LLLOYDS SURVEY.

Main Boilers
Nos 3804-3810

Riley Bros Ltd

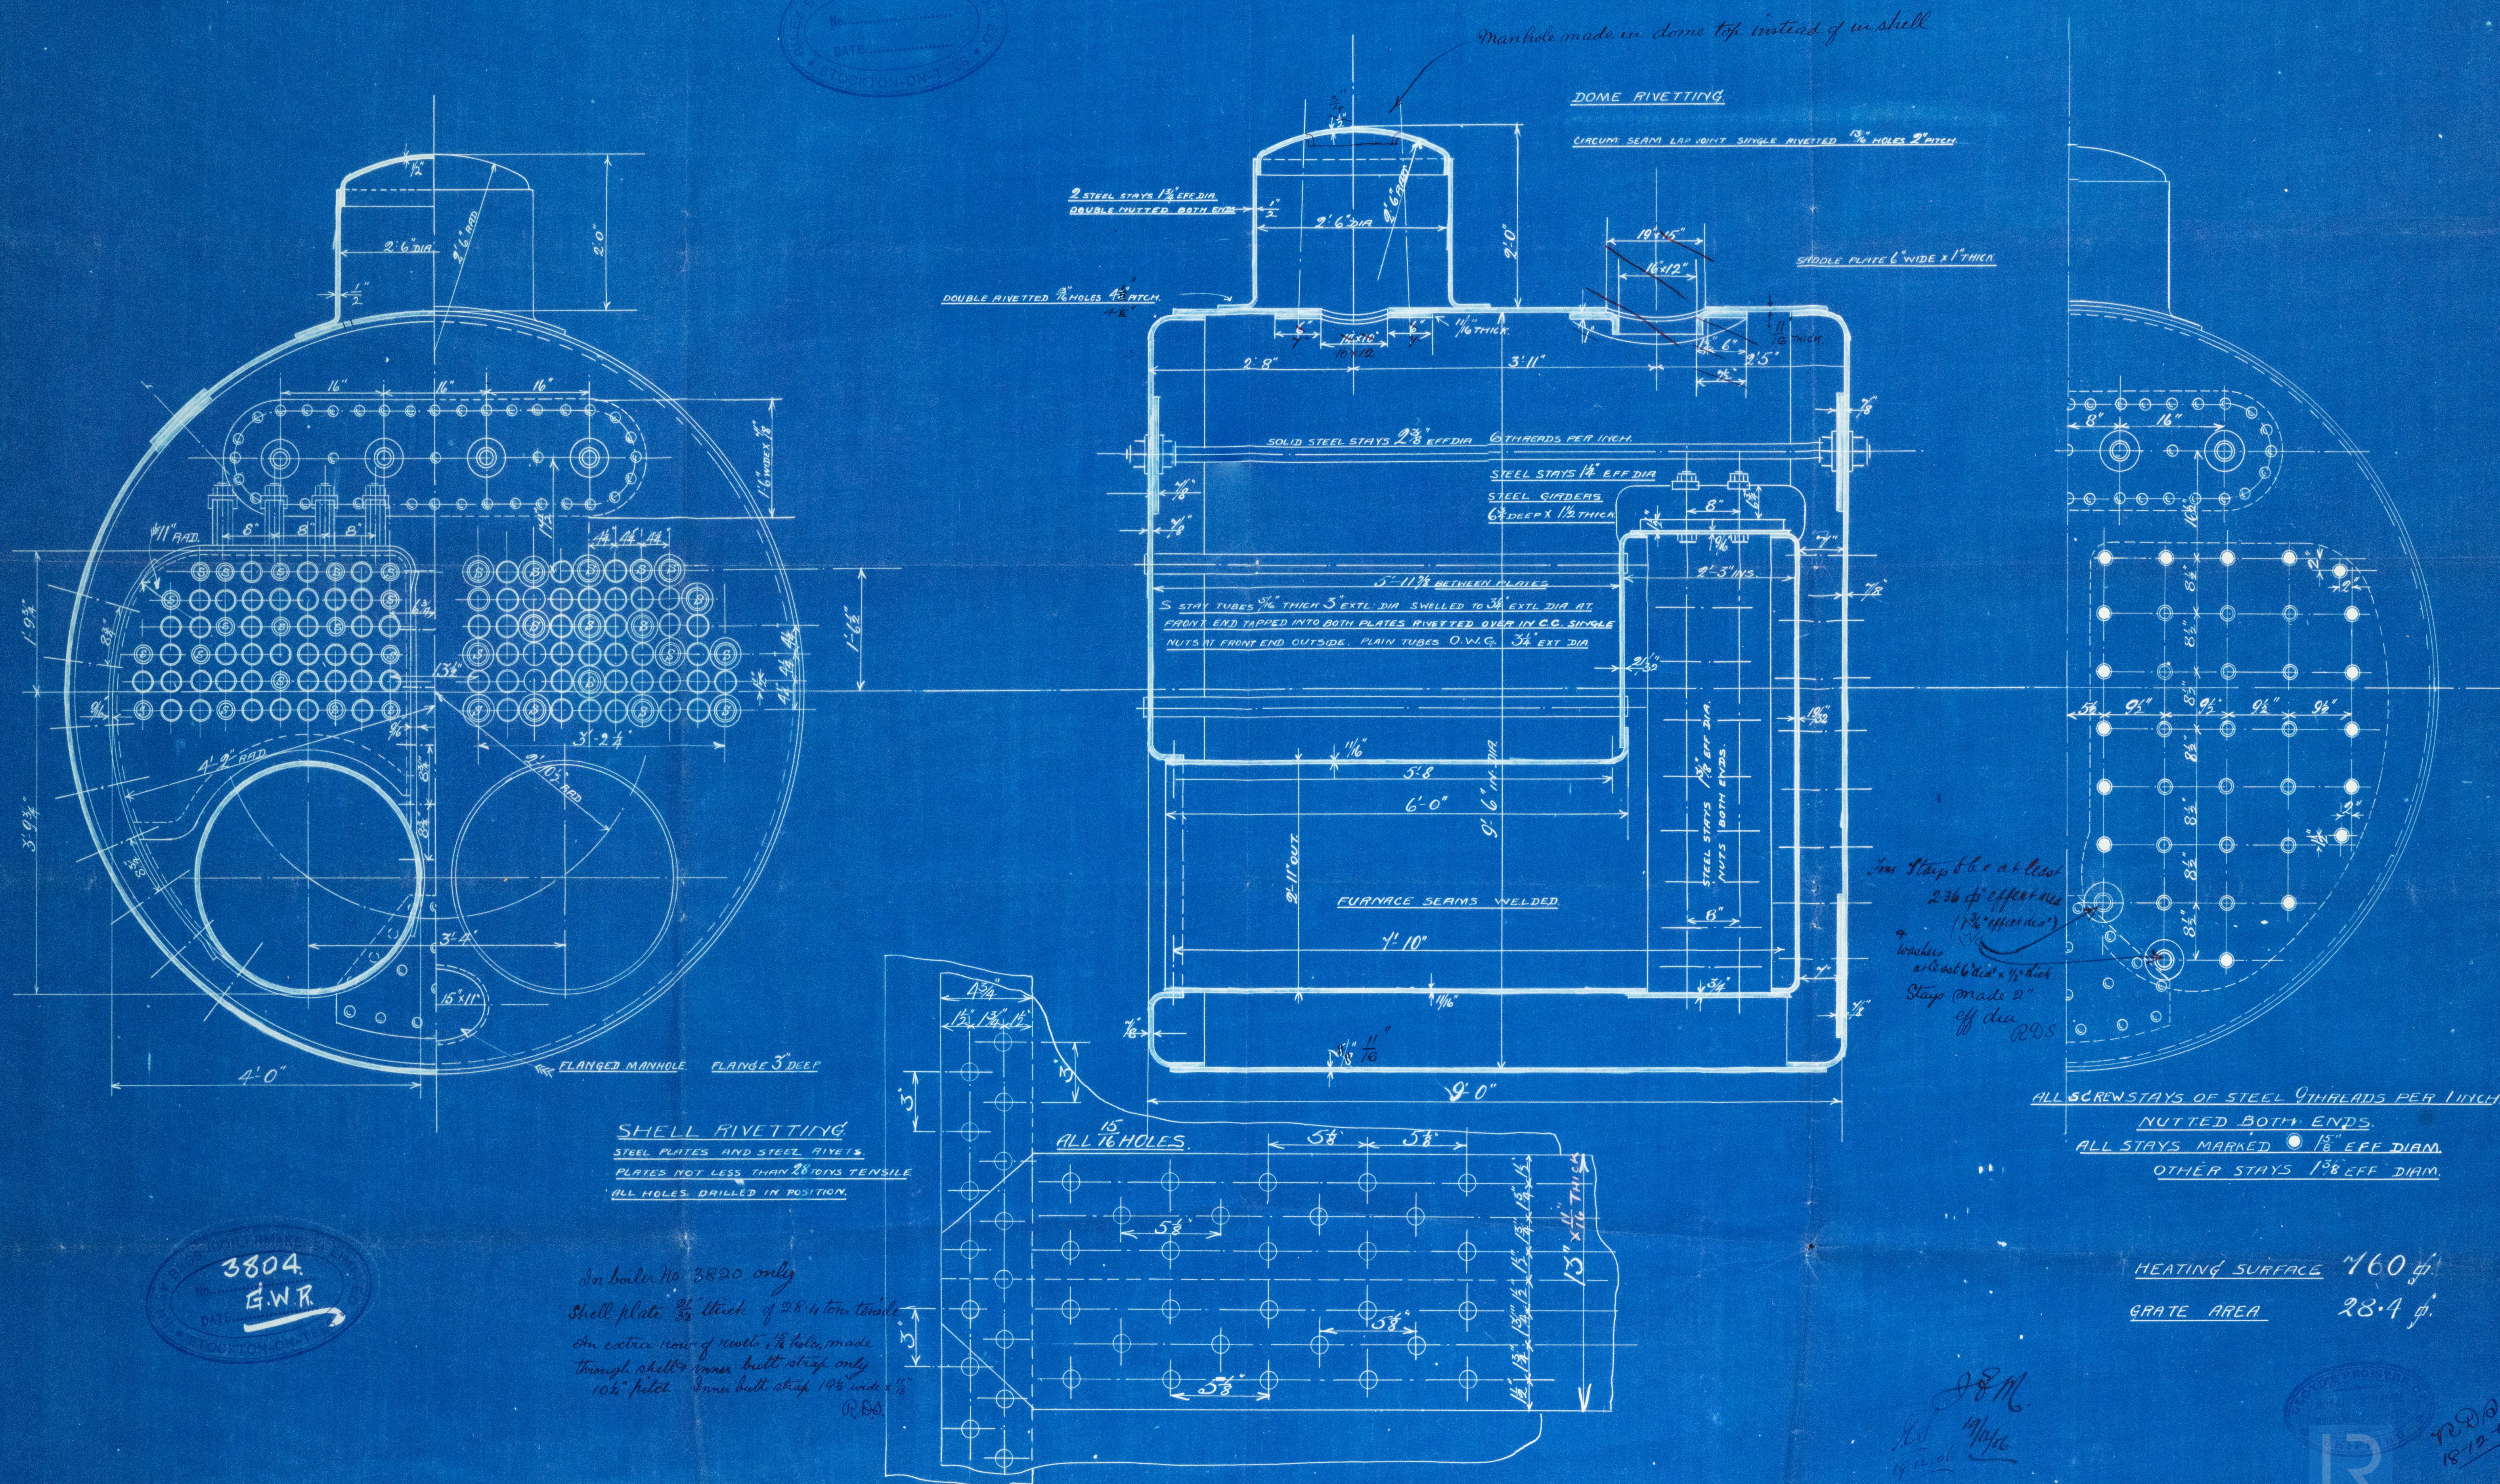
Ans. Slaps like at least
236 # of effort due
(13% effort due)
7
w/trackers
at least 6000 x 1/2 inch
Slaps made 2"
off dia
RDS

Also boiler No 3819. 20.21.
See Riley's letter of 19.3.07.
